**From:** Monica Messina <nikmess@hotmail.com>  
**Sent:** Thursday, September 5, 2024 7:09 PM  
**To:** Madison Landmarks Commission  
**Subject:** Re: 2nd try - Re: 1908 Arlington place proposed garage

The west-facing wall is 36 feet long and contains one door and two windows almost evenly spaced every 10-12 feet. Given that there will be greater than 13 feet of wall extending beyond the back wall of the house, it would seem more in keeping with the overall character of the architecture to include at least one window on the east-facing wall. Otherwise, the east-facing wall will appear like a towering wall.

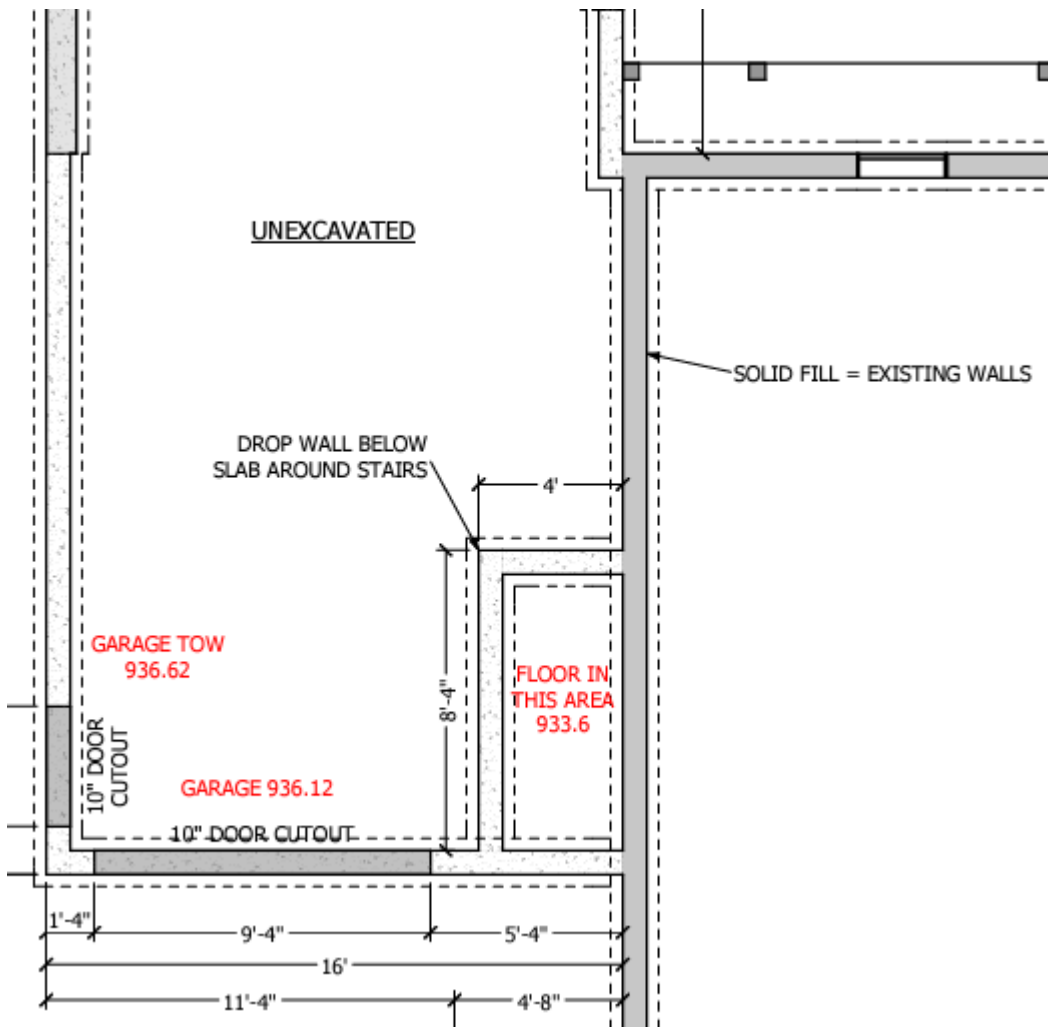
The reason I ask is because I am concerned about the east-facing wall not having windows at all. It looks like there are two windows planned on the west-facing wall, one in the rear, but that the east-facing wall will just be a window-less expanse of stucco. Am I seeing that correctly or missing something?

You're reading that correctly. That back corner of the building already has larger expanses without windows, but I also have concerns about just how much is on that wall. In my staff report (which should be posted soon), I'm recommending that they extend the foundation trim band so that it will read as a belt band on that part of the building to help break up that mass.

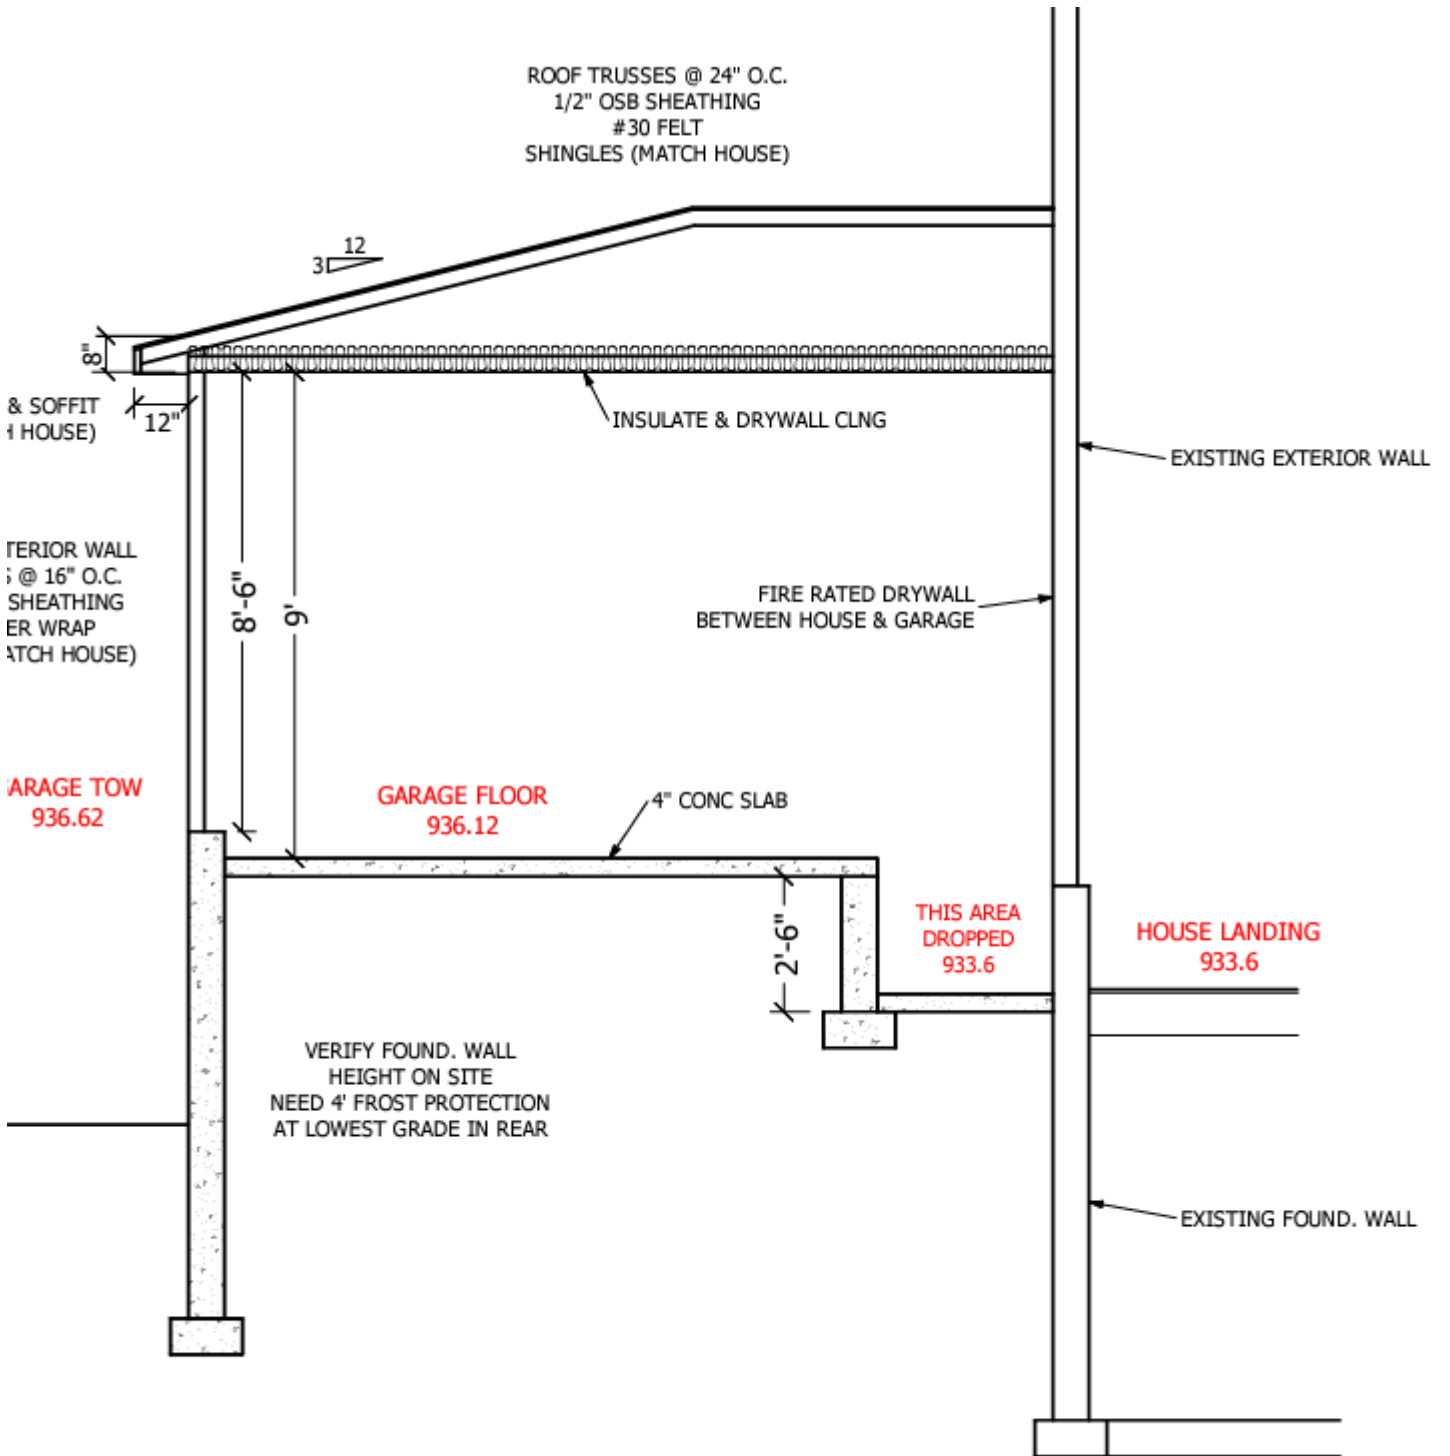
**My question:** will this structure also have basement space that connects to the existing basement?

The plans represent that the area below the garage is unexcavated and not accessible:

There is an area in the garage level with some steps down so that it can connect with the floor-level of the house:
